**Western Copper
Corporation**

Project Proposal
Carmacks Copper Project
Yukon Territory

**EBA Engineering Consultants Ltd., Response to Review
Questions – Waste Rock Storage Area
(May 2006)**

**Subject: Response to Review Questions – Waste Rock Storage Area
Carmack Copper Project – near Carmacks, YT**

**WASTE ROCK STORAGE AREA
LOADING PLAN**

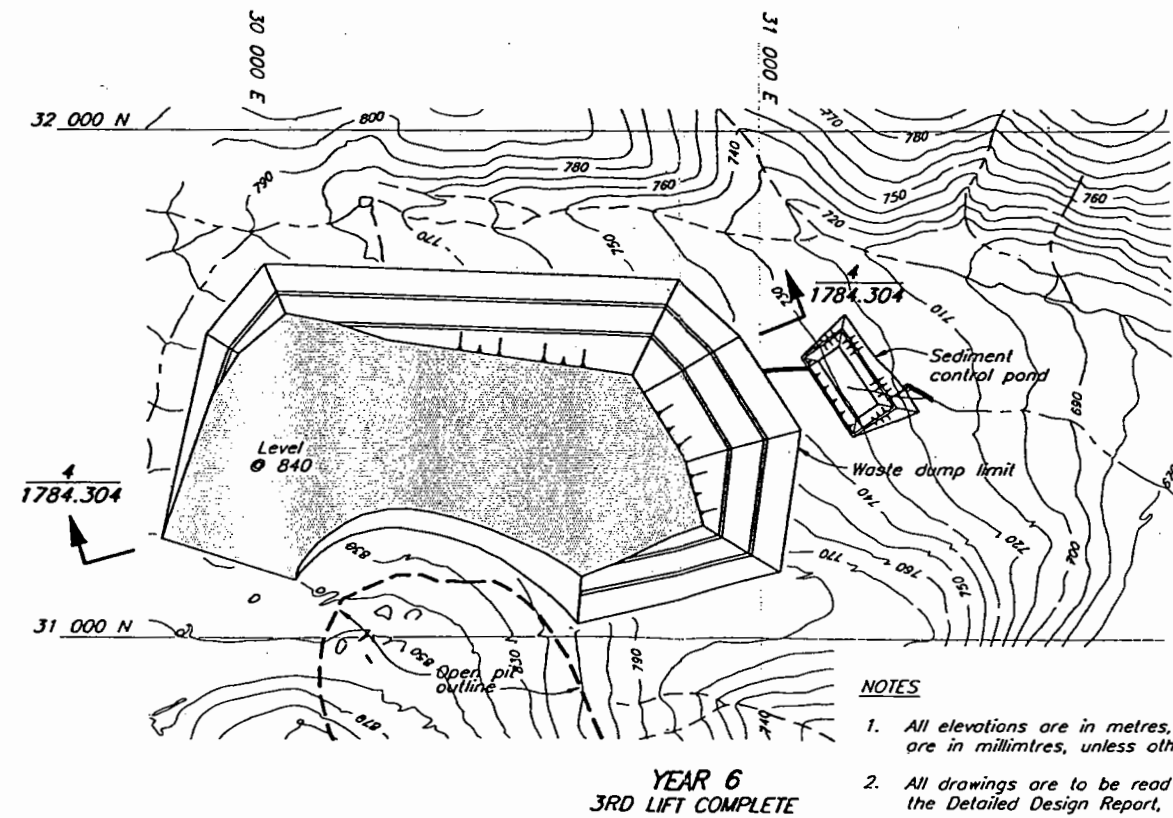
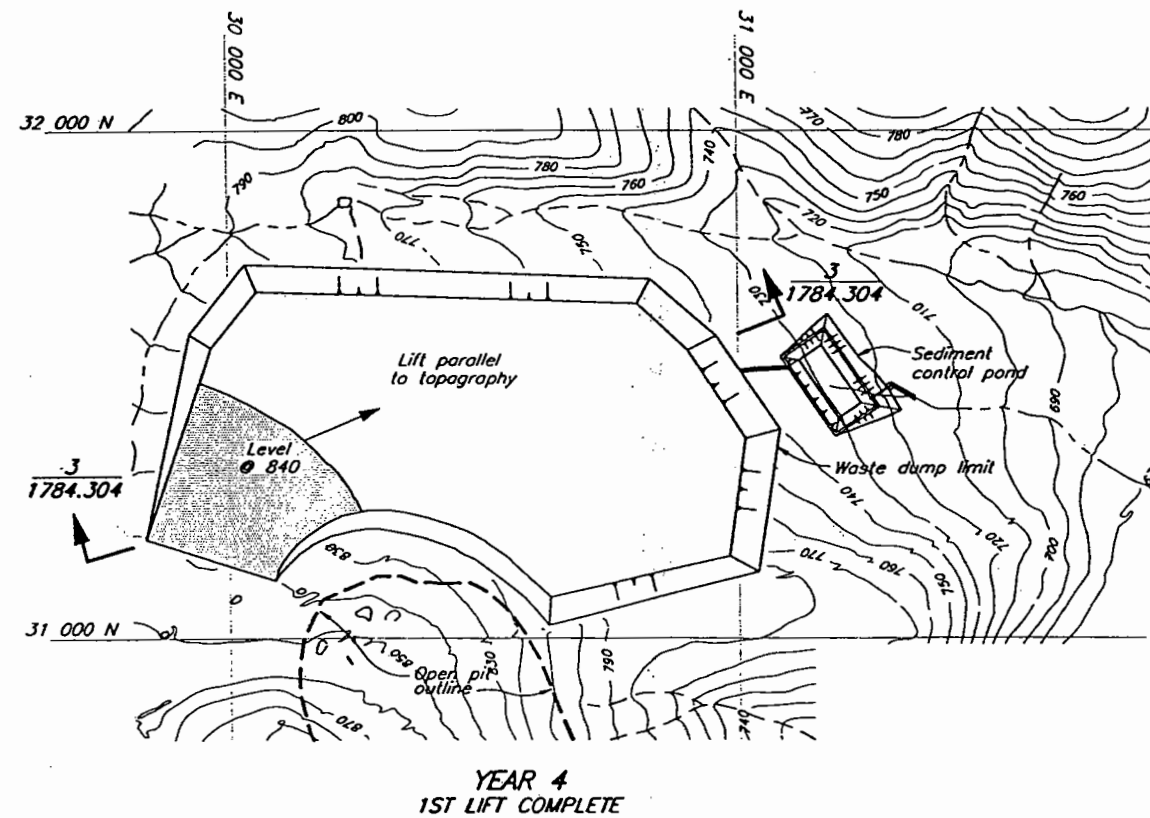
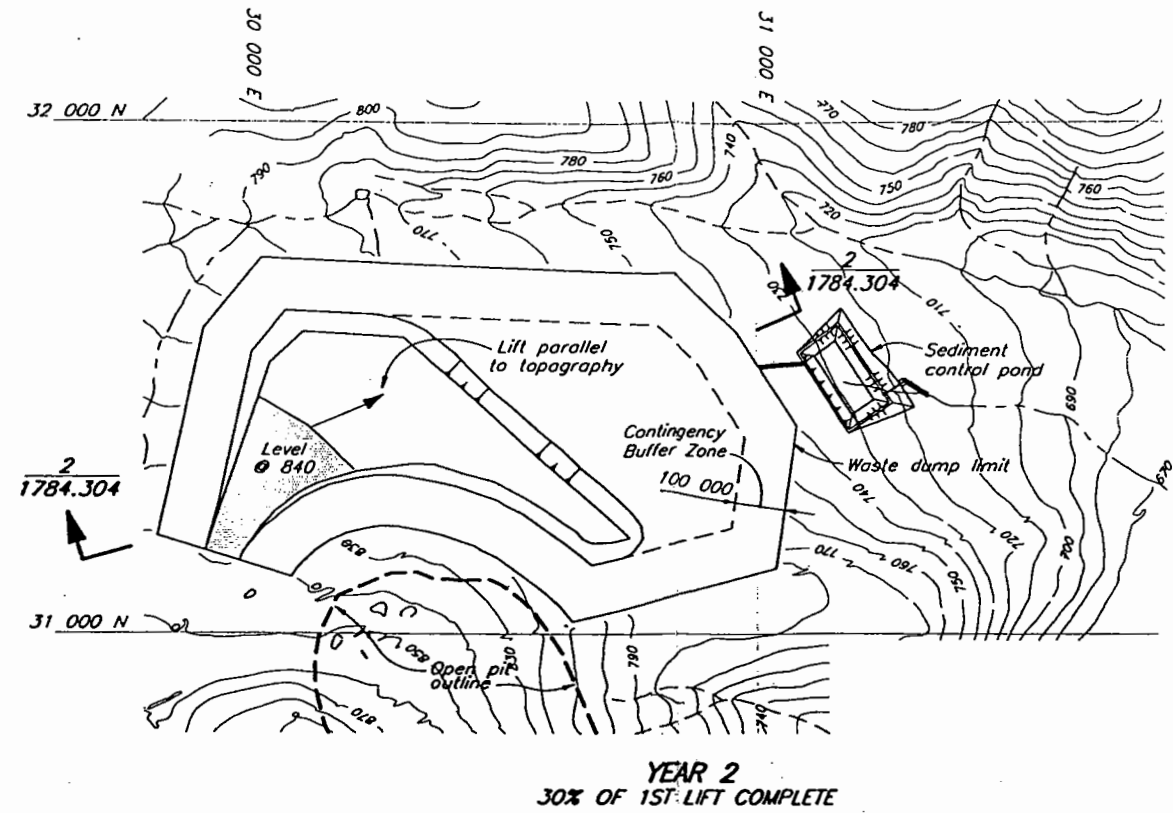
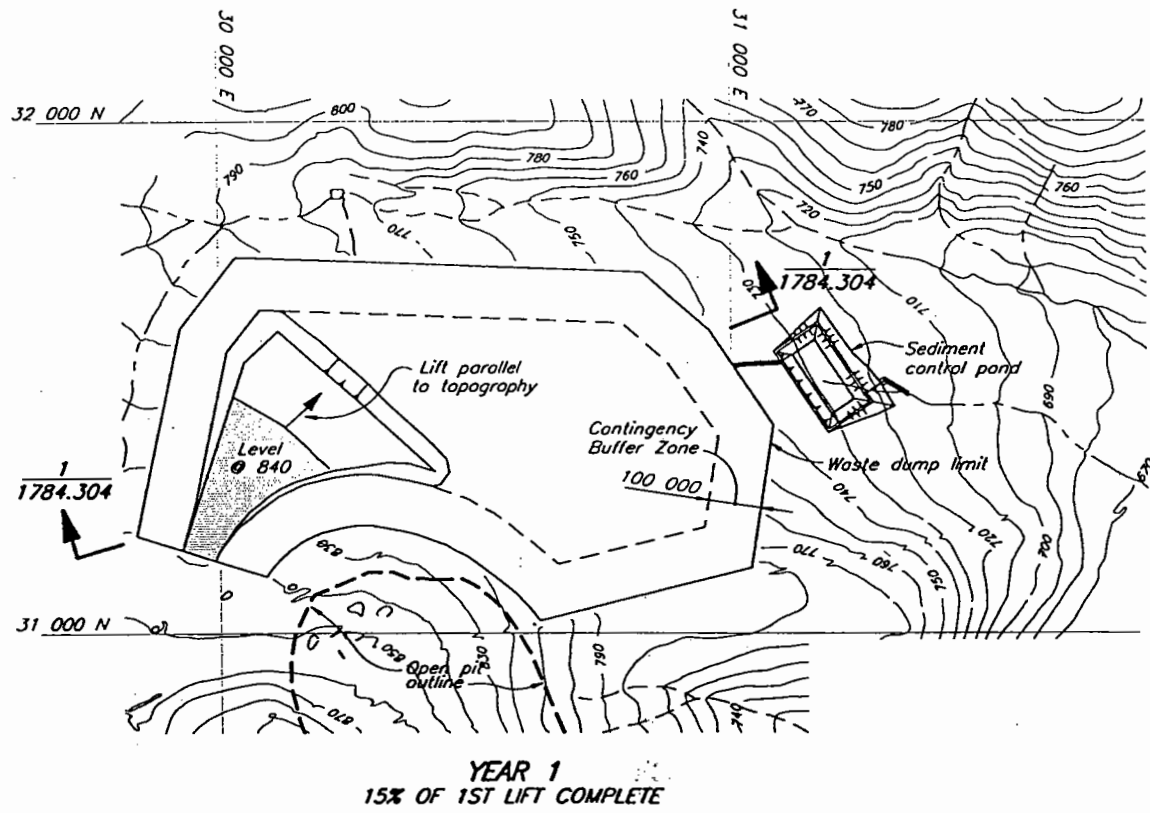
The following construction methodology has been summarized from the initial KP 1997 WRSA detailed design report. Drawings 1784.303 and 1784.304, attached, present the loading plan and sections for Years 1,2, 4 and 6 of the WRSA.

EBA finds this construction methodology acceptable based on the reported foundation conditions within the WRSA to date. The stripping operation in the pre-production stage along with the 100 m buffer zone for Years 1 through 3 will help address any stability concerns for the WRSA from thaw unstable soils (given permafrost is present). The Year 3 geotechnical investigation will provide the necessary information to address any further instability concerns for the WRSA prior to the filling in the buffer zone in Year 4.

Upon the completion of the 2006 geotechnical drilling program, this construction methodology will be reviewed and revised to incorporate the current foundation conditions present within the WRSA.
